SI B54 04 17
Special Roofs

CREAKING OR RATTLING NOISE FROM SUNROOF AREA

This Service Information bulletin supersedes SI B54 04 17 dated **October 2017**.

G12 (7 Series)			
----------------	--	--	--

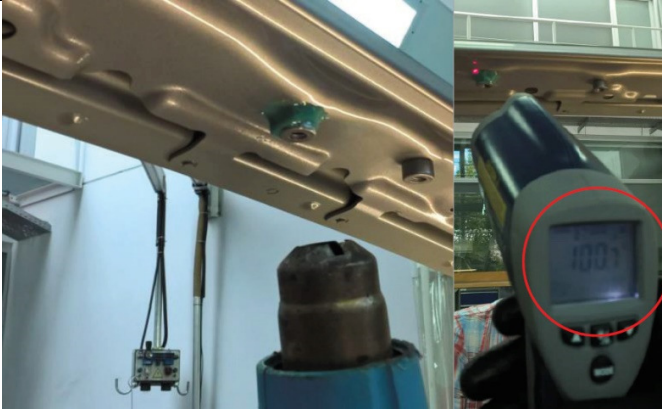
3. Reinstall the glass unit into the vehicle with new screws (1), be sure to install plastic washers (2) between the sunroof cassette and threaded bushing.
	4. Coat screw threads with medium-tight thread locking adhesive (Loctite 243) (BMW part # 83 19 2 210 339). Note: Tighten screws, with a torque wrench, to exactly 10 Nm. Over-tightening or under-tightening may lead to a loose connection and a repeat visit.
	5. Reassemble the balance of parts removed from the vehicle as per repair instructions. 6. Confirm the integrity of the repair by test-driving on an appropriate surface.

REPAIR INSTRUCTIONS FOR G12 SUNROOF NOISE

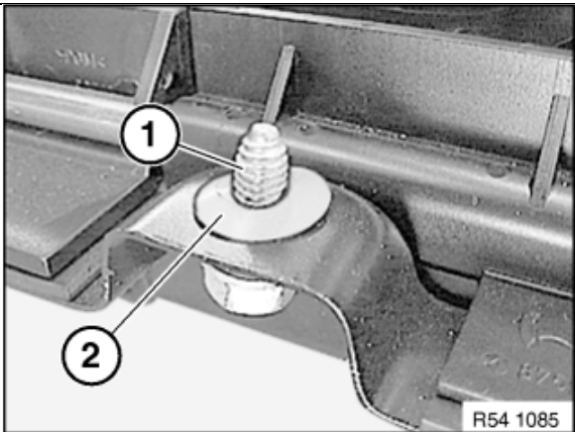
C. Use a cartridge gun (83 19 2 149 522) to apply K5a body adhesive around the side of each bushing as shown.
	 Note: Keep all adhesive off the flat surface of the bushing.
	D. Heat the applied adhesive with a heat gun to an approximate temperature of 175 to 212 degree F (80-100° C). Check the temperature with an infra-red thermometer. E. Apply another layer of adhesive to the side of the bushing repeating Steps 2C and 2D, above. F. Allow the adhesive to cure for at least 12 hours.
